ATTACHMENT VII

POST PUBLIC NOTICE ADDENDUM: October 2011

The draft NPDES permit for the ArcelorMittal Indiana Harbor East and ArcelorMittal Indiana Harbor Long Carbon were made available for public comment from August 15, 2011, through September 30, 2011, as part of Public Notice No. 2011-8F-RD/PH. In addition, a public hearing was held in Gary, Indiana, on September 15, 2011. During the comment period and at the public hearing, comments were received concerning the draft permit. Comments received at the hearing and/or submitted via email, and this Office's corresponding responses, are summarized below. Any changes to the permit and/or fact sheet are so noted below.

Mr. Kevin Doyle, Environmental Manager, ArcelorMittal USA LLC submitted the following comments on behalf of the permittee for the following permits: Indiana Harbor East (IN0000094) and Indiana Harbor Long Carbon (IN0063355).

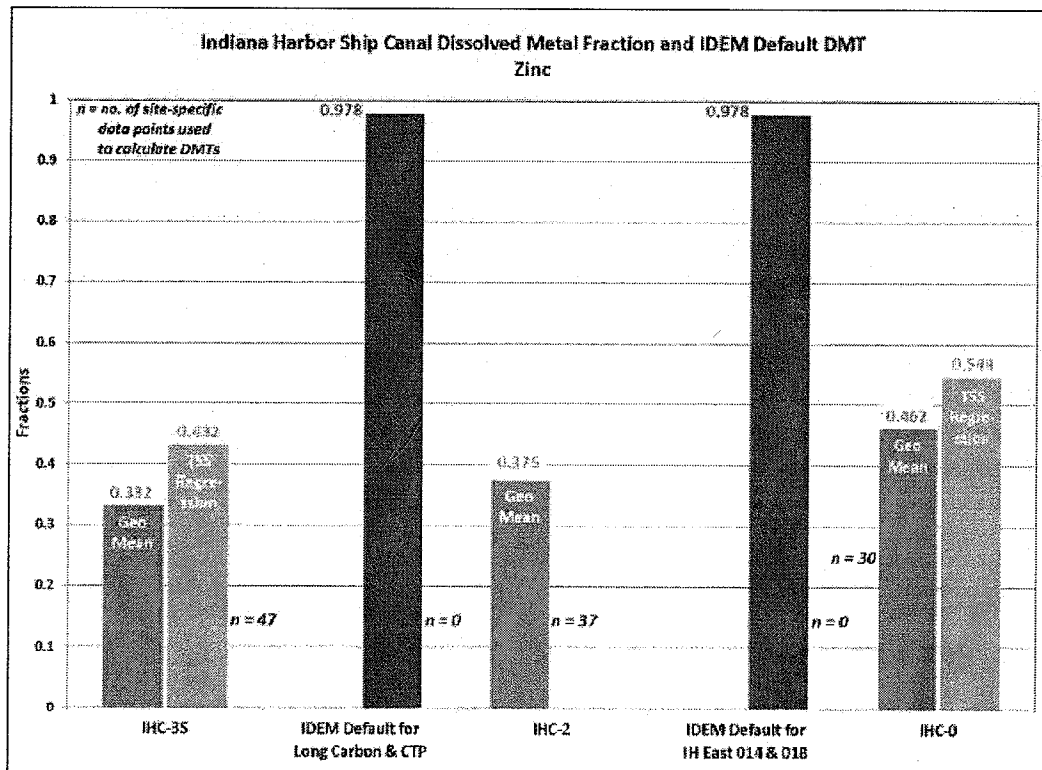
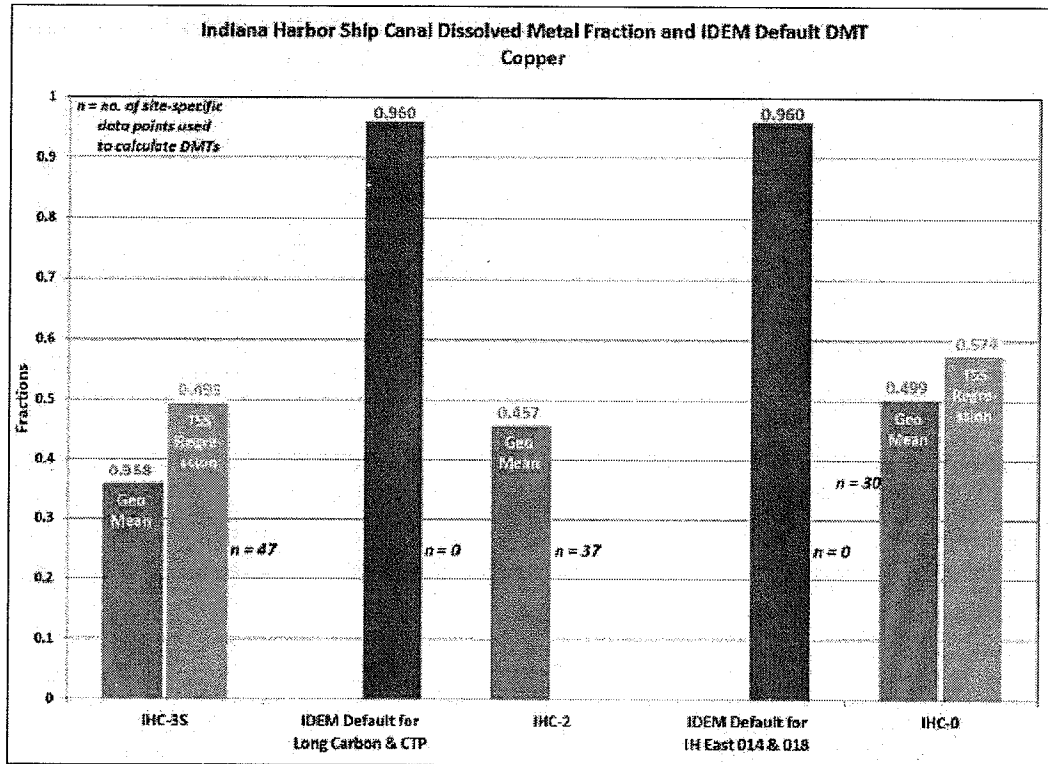
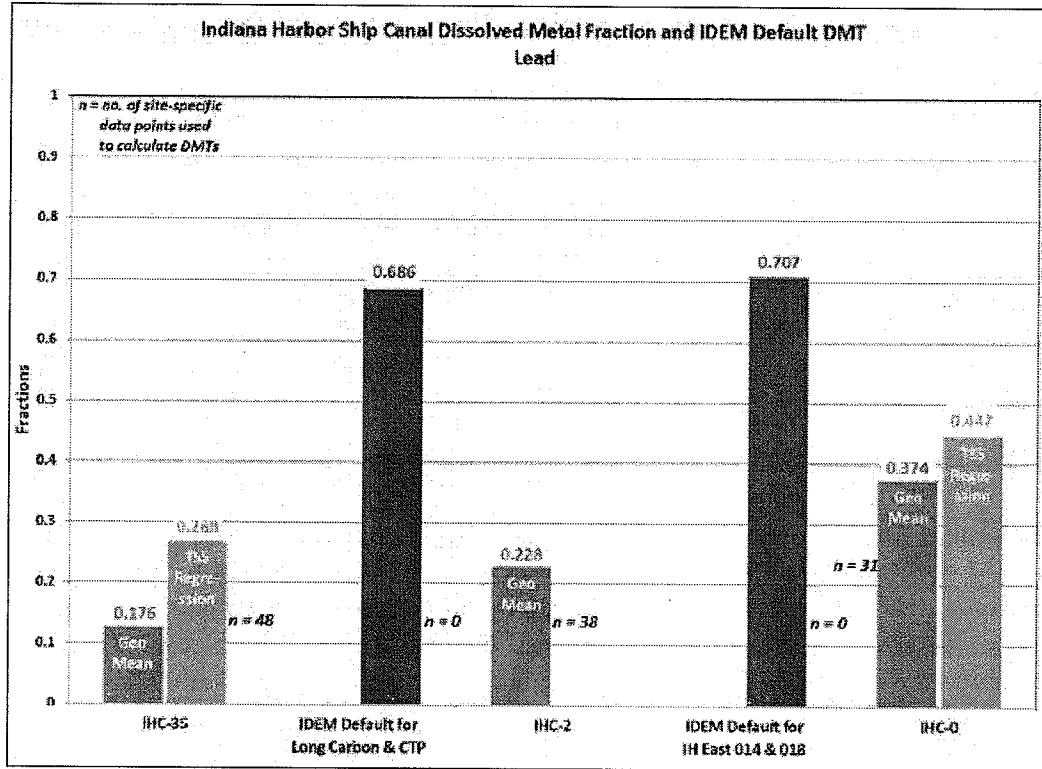
Total and dissolved data for copper, lead and zinc collected by IDEM from the Indiana Harbor Ship Canal at fixed monitoring stations IHC-2 (Dickey Road) and IHC-0 should be used to calculate site-specific dissolved metals translators (DMTs). These DMTs should be used in the calculation of preliminary water-quality based effluent limits for the Central Treatment Plant (CTP) Outfall 001,

and Indiana Harbor East Outfall 014. Data collected by IDEM over a period of several years for these metals demonstrate that the majority of the copper, lead and zinc present is associated with particulate in the water column and is not in the dissolved form. Dissolved metals more closely approximate the bioavailable fraction in the water column than do total or total recoverable metals.

Consequently, use of site-specific DMTs is well suited for the IHSC. The Dickey Road fixed monitoring station, located downstream of CTP Outfall 001, serves as an appropriate data set for calculating DMTs for development of WQBELs for CTP Outfall 001. IDEM should consider the Dickey Road data representative of conditions in the IHSC and reliable because IDEM used the lead and zinc data collected at Dickey Road for another purpose in the NPDES permit renewal process for the ArcelorMittal facilities (*i.e.*, Dickey Road data were used to project the effluent quality from Indiana Harbor West Outfall 007 in IDEM's multi-discharger WLA). The IHC-0 fixed monitoring station is located downstream of Indiana Harbor East Outfall 014.

As noted in a prior response, IDEM does not believe it is acceptable to re-establish background at Dickey Road and has not received a site-specific metals translator study so the current multi-discharger model was not revised. IDEM did look at the impact of lowering the ArcelorMittal Long Carbon allocation, as requested, and did not find a significant impact on the calculation of downstream WQBELs. For future wasteload allocation considerations, a site-specific metals translator along with more refined effluent concentration characteristics will provide the greatest means of showing that more assimilative capacity is available than currently modeled.
